# STAFF RECOMMENDATION

NCPC File No. 3031

**UNITED STATES GEOLOGICAL SURVEY (USGS),  
JOHN WESLEY POWELL BUILDING  
WIRELESS COMMUNICATIONS ANTENNAS  
12201 Sunrise Valley Drive  
Reston, Virginia**

October 25, 2007

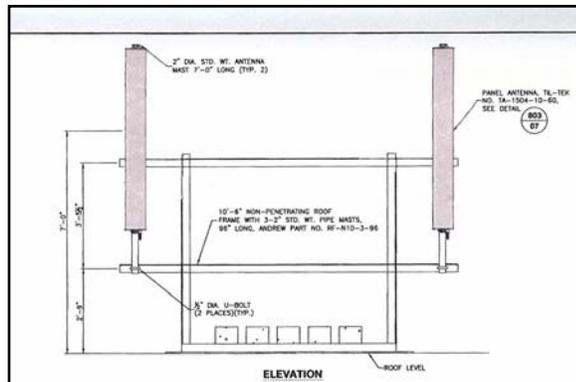
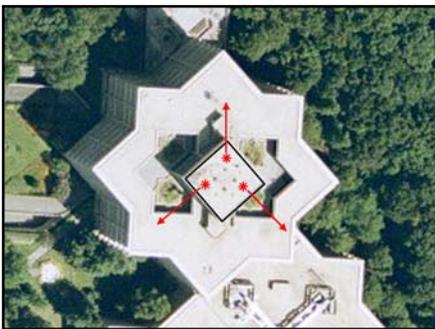
Additionally, four auxiliary cabinets will be located within the existing penthouse mechanical room. According to the site plan the locations of the three panel antenna sectors, and one GPS antenna, on the penthouse rooftop will be as follow:

- One panel antenna sector at the north corner penthouse mechanical room directed to the north
- One panel antenna sector near the western corner of the penthouse mechanical room directed west-southwest
- One panel antenna sector near the eastern corner of the penthouse mechanical room directed east-southeast
- GPS antenna location not indicated other than on rooftop of penthouse mechanical room

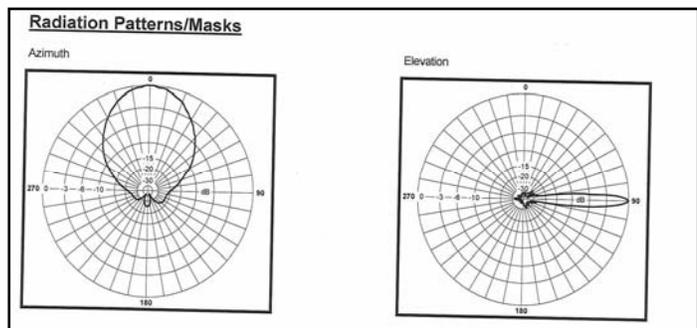
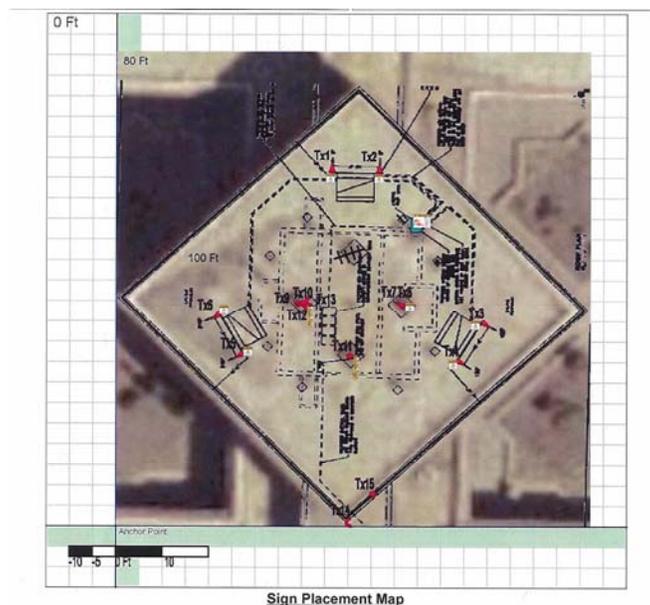
The results of the analysis indicate that a small portion of the rooftop has the potential of exceeding 100% occupational MPE. The areas where this may occur are located immediately in front the proposed panel antennas and around some existing antennas located near the middle of the rooftop. The extent or distance of these areas away from the proposed panel antennas is minimal and will not extend past the roofline in any direction.

The area of the rooftop that may exceed 100% general public MPE is a bit more extensive than the occupational exposure potential and covers a significant portion of the rooftop area. It appears that most of the RF emissions in this area are attributable to already existing antennas located near the middle of the rooftop and directed to the northwest. The proposed panel antennas will add to the total area of rooftop that may exceed 100% general

public MPE. This additional area will be located immediately in front of the proposed panel antennas and will extend to the roofline. This area may extend past the roofline, however, considering the narrow horizontal radiation pattern of the proposed panel antennas exposure to areas below the roofline would be improbable.

**Staff recommends** that the Commission accept the recommendations included in the RF analysis and provided above as part of its approval of this project.

**Staff recommends** that the Commission highlight to the GSA that access to the penthouse roof areas should be controlled and locked if possible. Moreover, GSA should ensure that necessary RF warning signs are placed at all rooftop access points in a highly visible fashion.

**Staff recommends** that the Commission highlight to the GSA that roof drawings should be posted on the penthouse walls and/or doorways indicating areas where the MPE for the general public and occupational standards could exceed 100%.
